UNITED STATES PATENT AND TRADEMARK OFFICE

Office Action Summary

10/650,321

HANCOCK ET AL.

FIG. 1

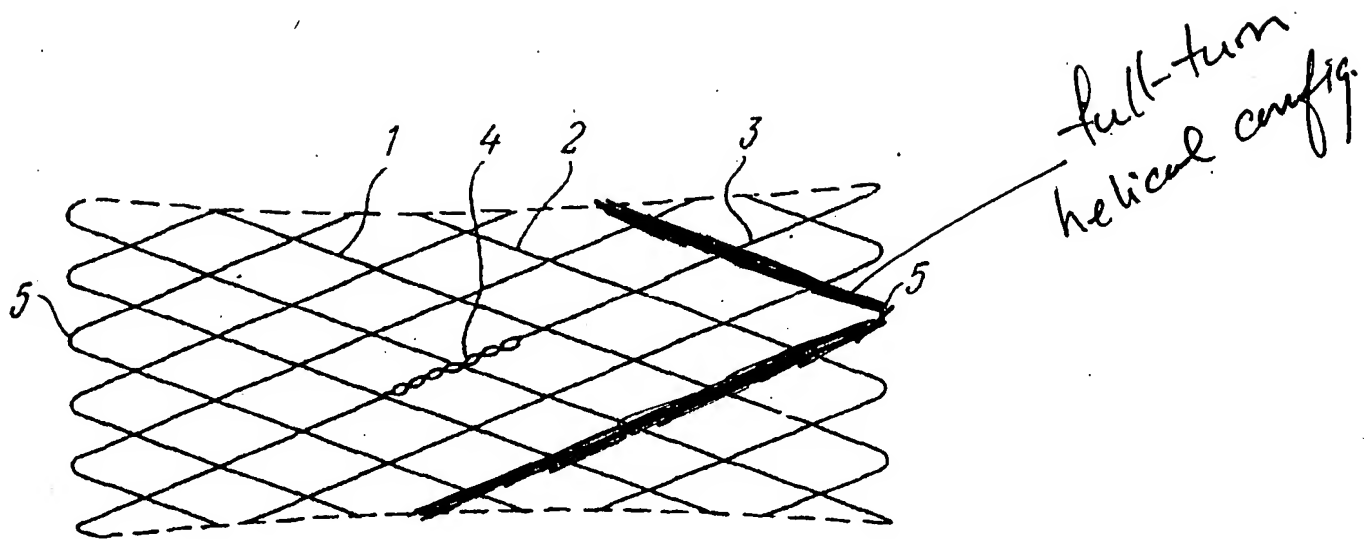
After a careful examination of the applicant's new limitations and remarks the Examiner maintains the previous rejection. The Examiner has interpreted the limitations "a full-turn helical configuration" as follows: as shown in Figures 1-3 and the specification, the fiber (1) clearly extends through out the circumference of the stent by helically wounding the fiber around the surface of the stent (see attachment).

Regarding the Applicant's remarks, the examiner understand the Applicant's point of view, however, the Applicant's representative has to enter more limitations in order to limit the full-turn helical configuration at the first or second ends of the tubular body.
